SERVICE *No.* 802 BULLETIN

Piper Aircraft Corporation
Vero Beach, Florida, U.S.A.

SUBJECT: Aft Bulkhead (Fuselage Station 332.0)
Inspection

PA-31P Pressurized Navajo 31P-3 through 31P-7730012

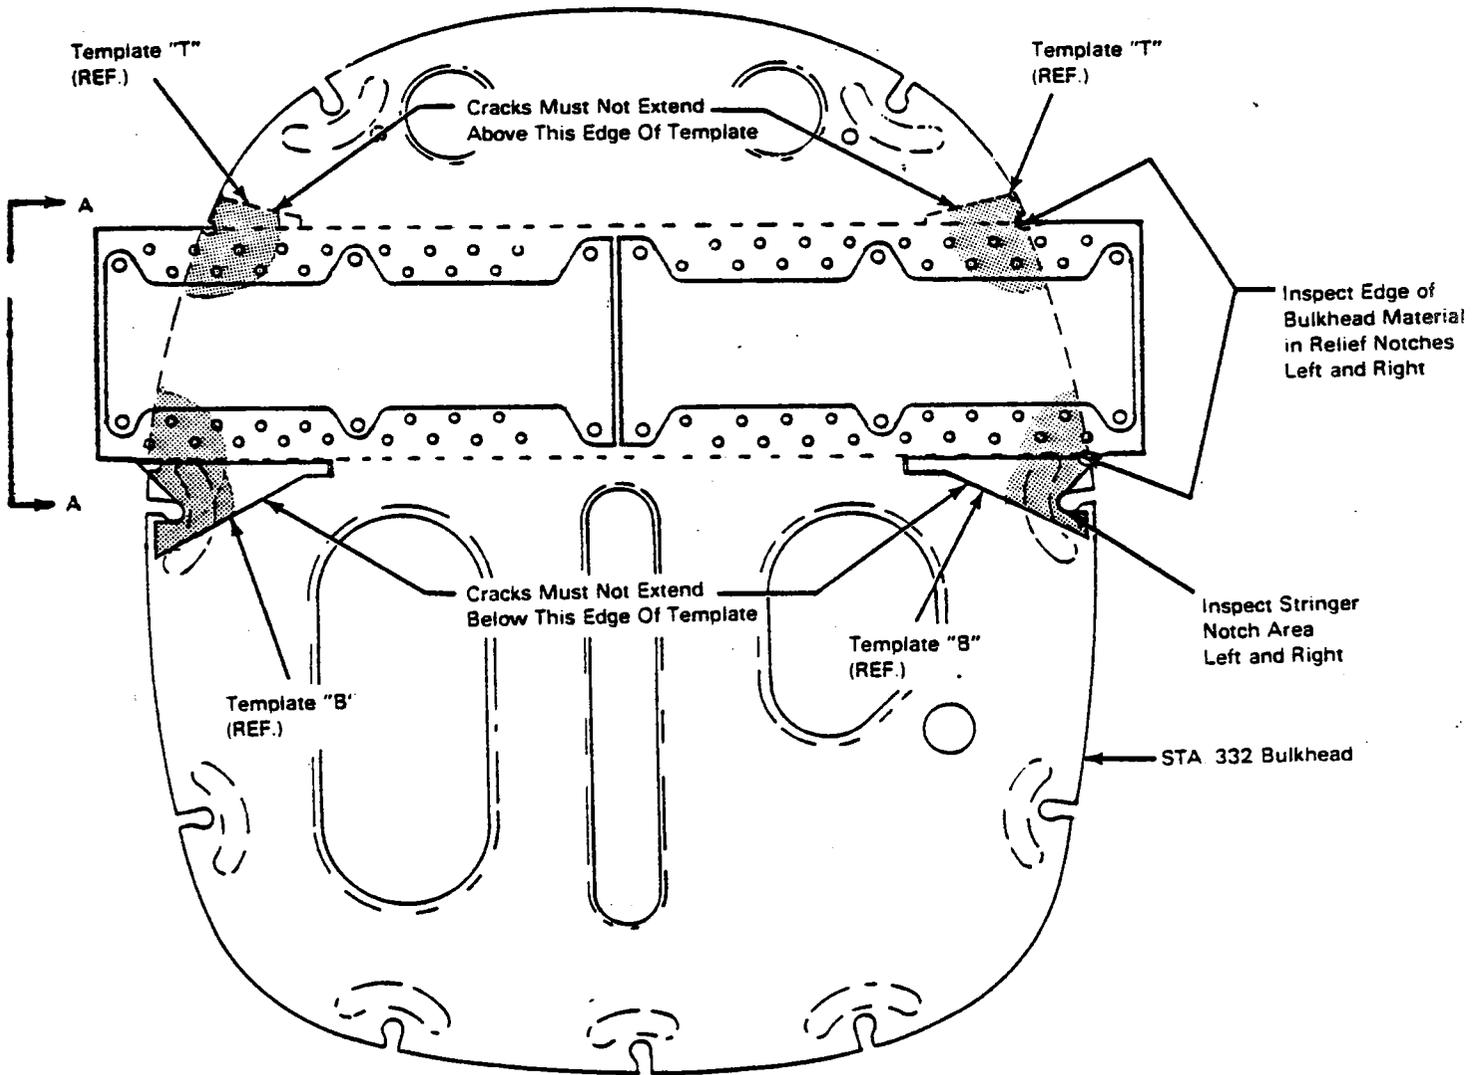
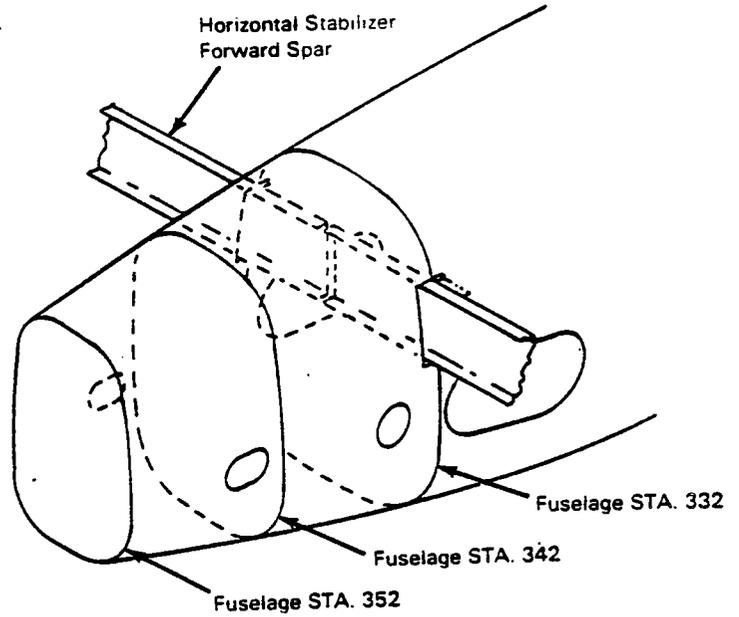
1. Gain access to the bulkhead area shown in Sketch A (attached) by removing the wrap-around fairings from the horizontal stabilizer to the fuselage and the access plates in the Station 332.0 area.
2. Using Dye Penetrant Inspection method, inspect the Fuselage Station 332.0 bulkhead for cracks in the areas shown in Sketch A.
 - a. If no cracks are found to exist, proceed to Instruction 3 below. A repetitive inspection is required at each 200 hours of operation.
 - b. If cracks are found, and cracks do not exceed the following limitations, cracks must be stop-drilled and Reinforcement Kit, Piper Part Number 764-983, must be installed before further flight.

LIMITATIONS: Cracks which originate at the relief notches or stringer cut-outs (See Sketch A) which do not exceed 1.5 inches in length and which do not extend above the top edge of Template "T" or below the bottom of Template "B" may be repaired per Instruction 2.b.

- c. If cracks are found to exceed the specified limitations, replace bulkhead assembly with Reinforced Bulkhead Assembly, Piper Part Number 45583-16, before further flight.
3. Reinstall fairings and make appropriate logbook entry of compliance.

SKETCH "B"

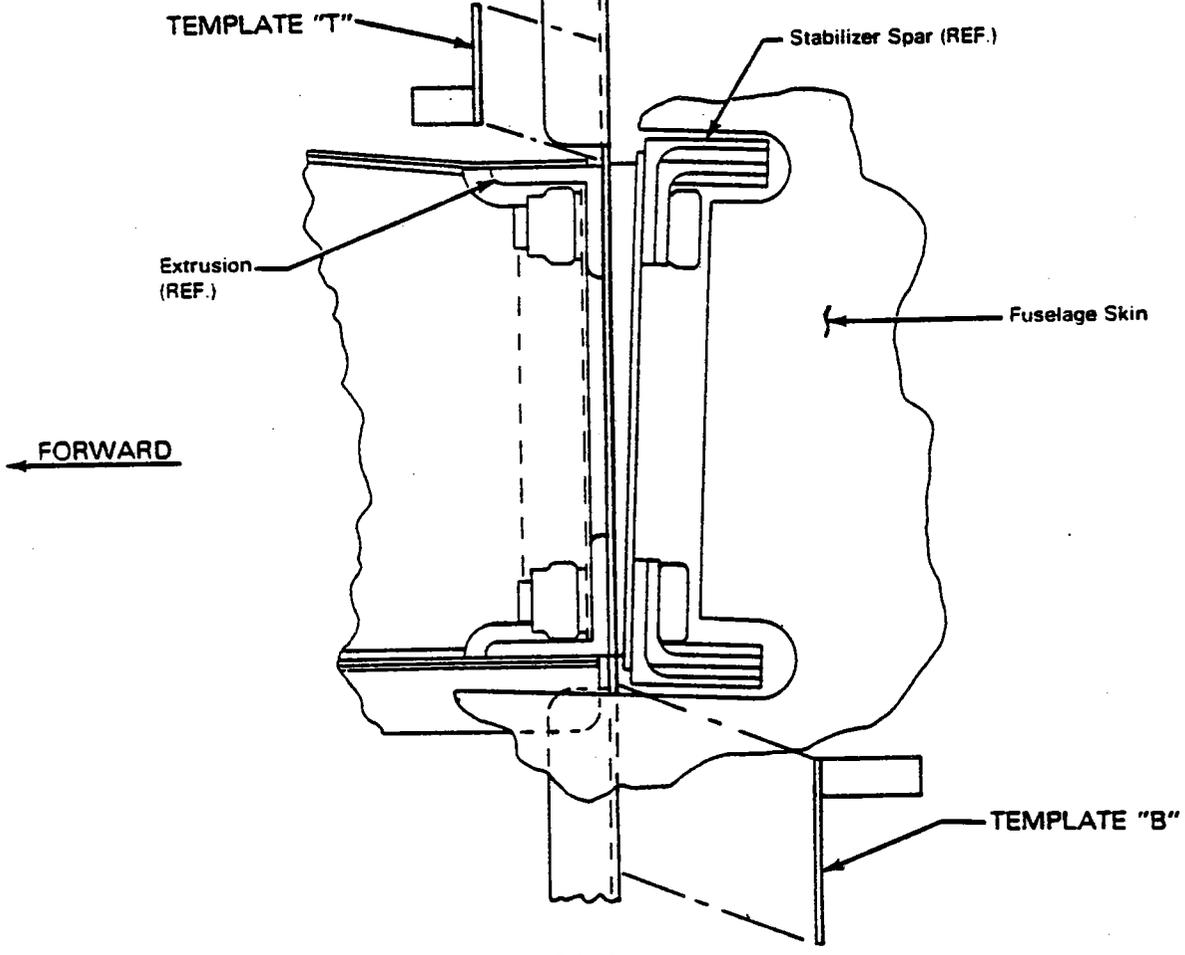
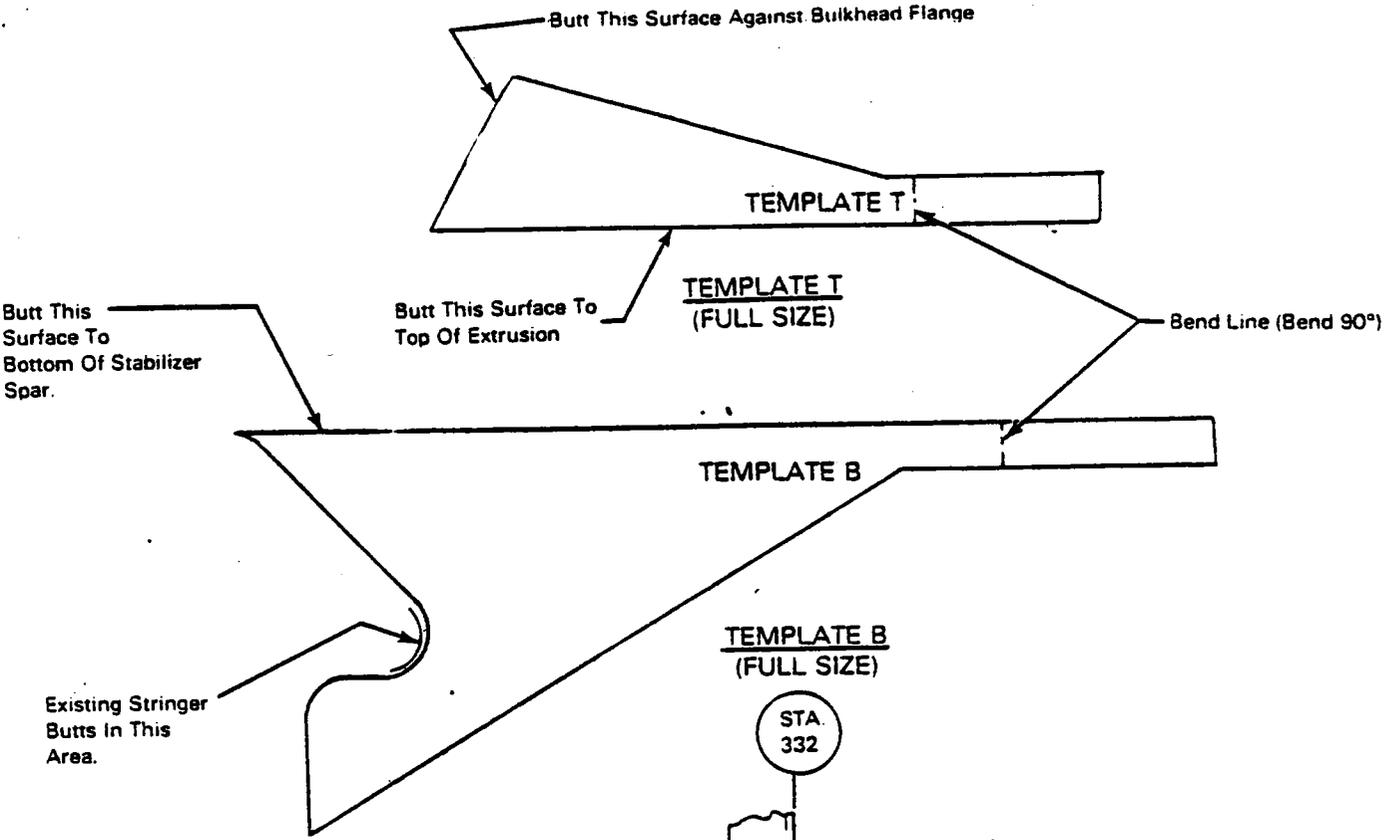
NOTE
Bulkheads With Cracks In Areas Denoted By Shading (See Limitations) May Be Repaired Per Instruction 2b.
